Our File/N/Réf.	25 10-96-R01901
Your File/V/Réf.	
DATE	30 August 1996
TO/DEST.	Co-ordinator Transportation Committee
FROM/EXP.	Director, Transportation Planning Division Environment and Transportation Department
SUBJECT/OBJET	TEMPORARY ACCESS TO RIVERSIDE DEVELOPMENT CONSTRUCTION OF A SOUTHBOUND LEFT TURN LANE AND ASSOCIATED ROAD WORKS ON RIVER ROAD (REGIONAL ROAD 19) NORTH OF ARMSTRONG ROAD

Re: Temporary Access To Riverside Residential Development
on River Rd

DRAWING NO.		SHEET 1 OF 2	
THE REGIONAL MUNICIPALITY OF OTTAWA-CARLETON		CONTRACT NO.	
TRANSPORTATION DEPARTMENT		14840-03	
RIVERSIDE		TEMPORARY ACCESS - RIVER ROAD	
KEY PLAN		DATE: AUGUST 1988

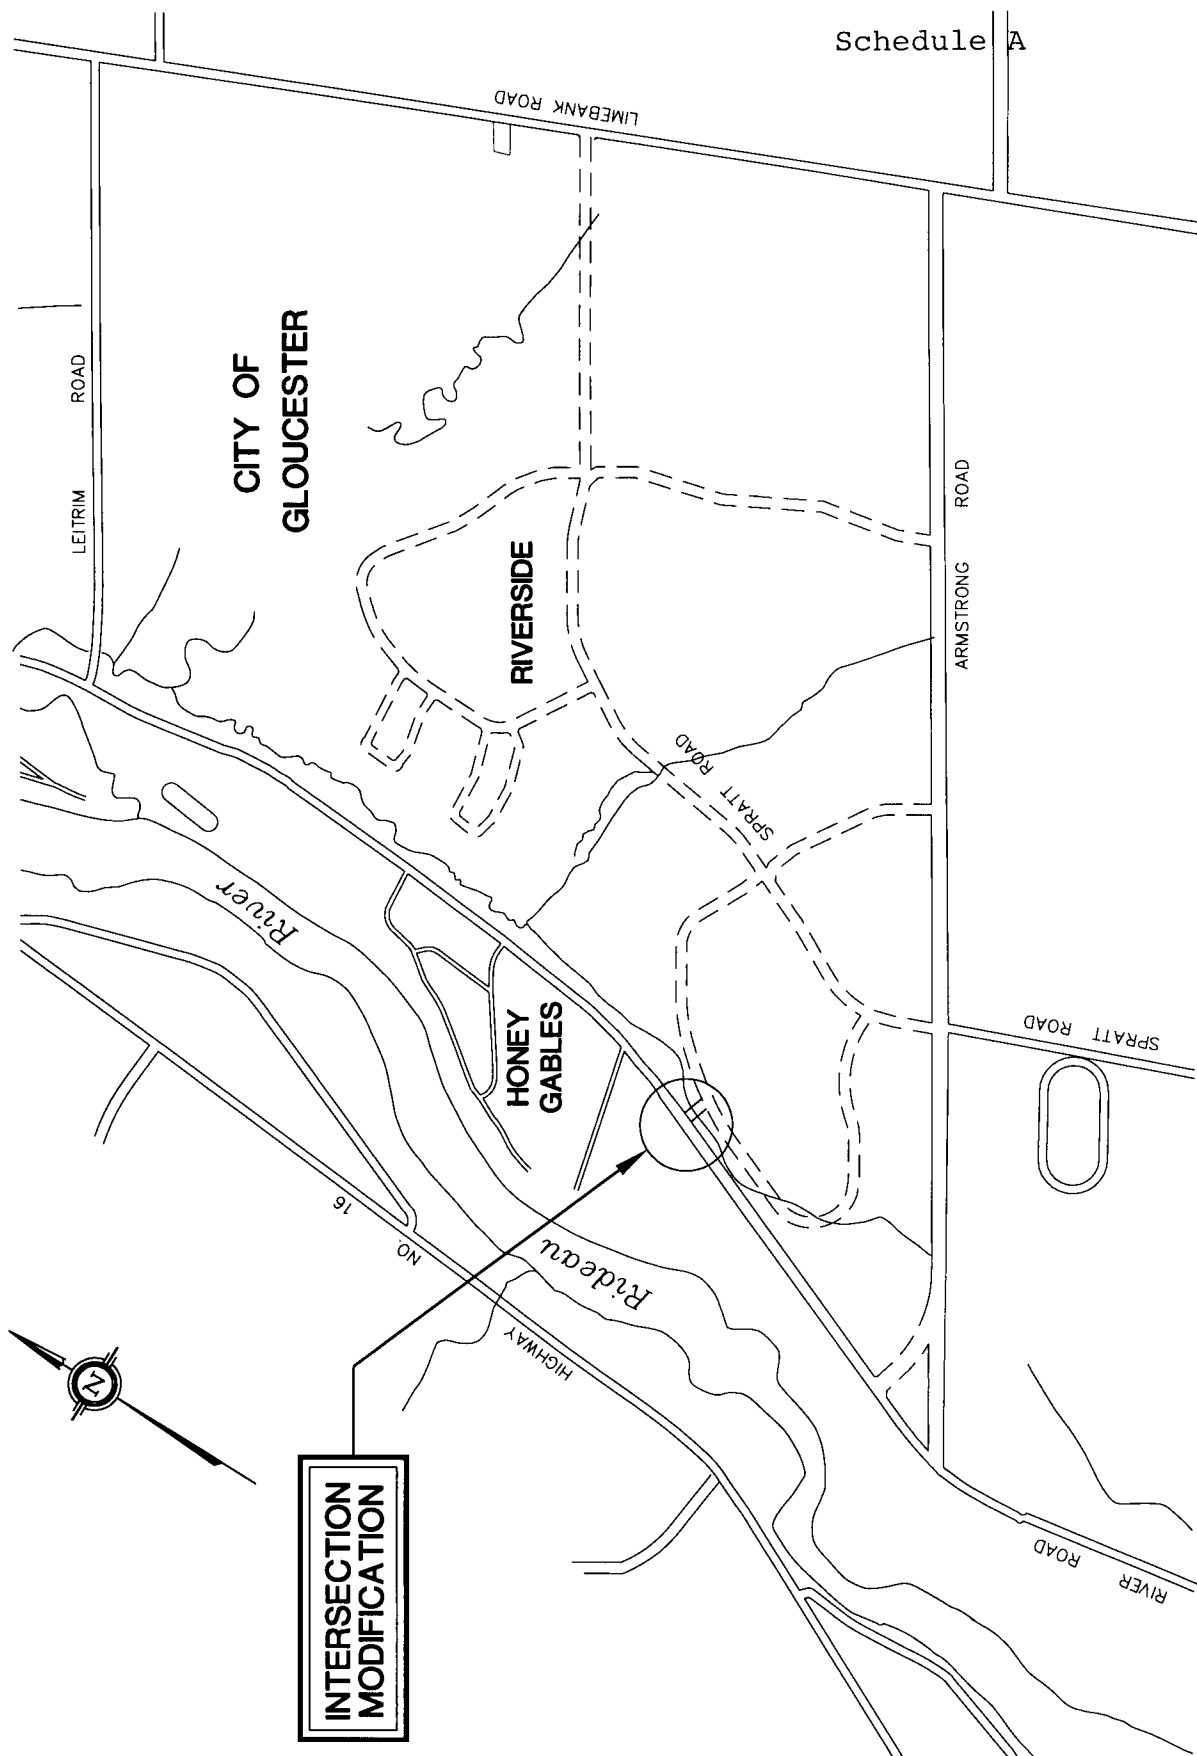
With reference to the above report the RCAG committee has the no objections to the proposed development. RCAG is pleased to note that the design shows no narrowing of the existing through lanes with the addition of the turning lane. This will be appreciated by cyclists who must share the lanes with motorized traffic.
